V8 XJ Series/XK

303-52

TECHNICAL BULLETIN

Difficult Or Non-Start/Hesitation – Normally Aspirated AJ 27 Engines – Reflash ECM

ILLUSTRATION 1

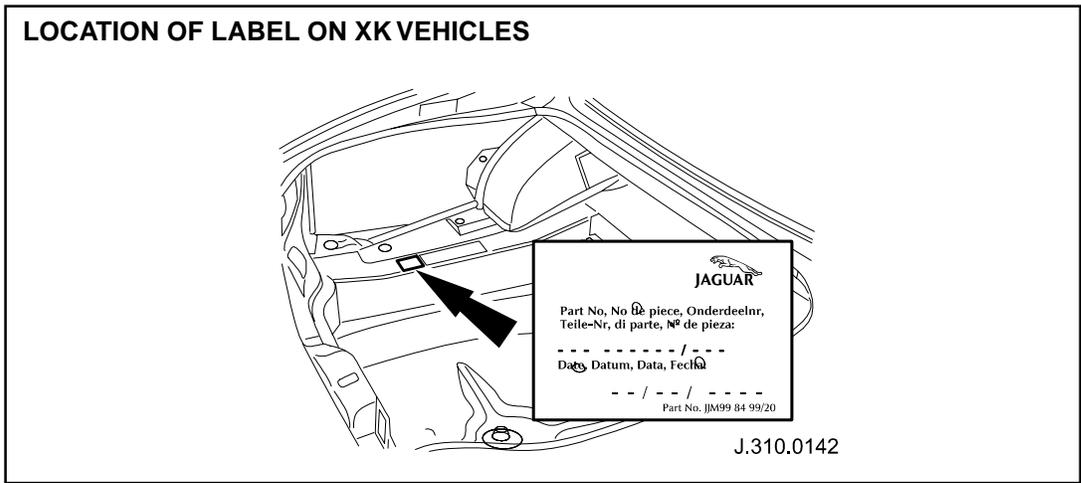
5. Navigate to configuration main menu; select and run 're-configure existing ECM'.
6. After reprogramming of the ECM is complete, switch 'OFF' PTU, disconnect and return WDS to original location.
7. On XK series vehicles fit generic update label (JJM 998499/20) alongside the VCATS label in the trunk with revised part number (from previous table), and date of re-configuration added to label (Illustration 1).

ILLUSTRATION 2

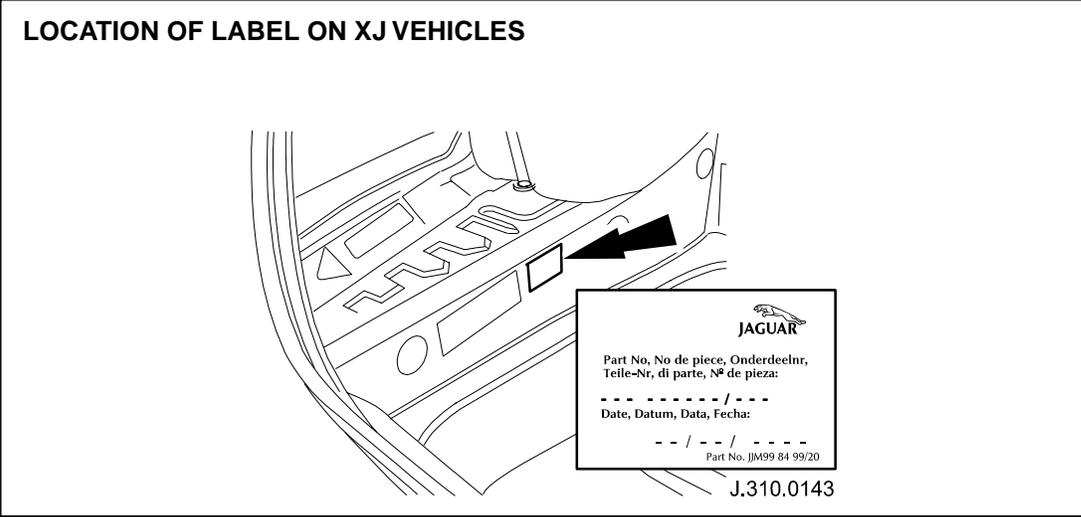
On V8 XJ series vehicles fit generic update label (JJM 998499/20) alongside the VCATS label in the trunk with revised part number (from previous table), and date of re-configuration added to label (Illustration 2).
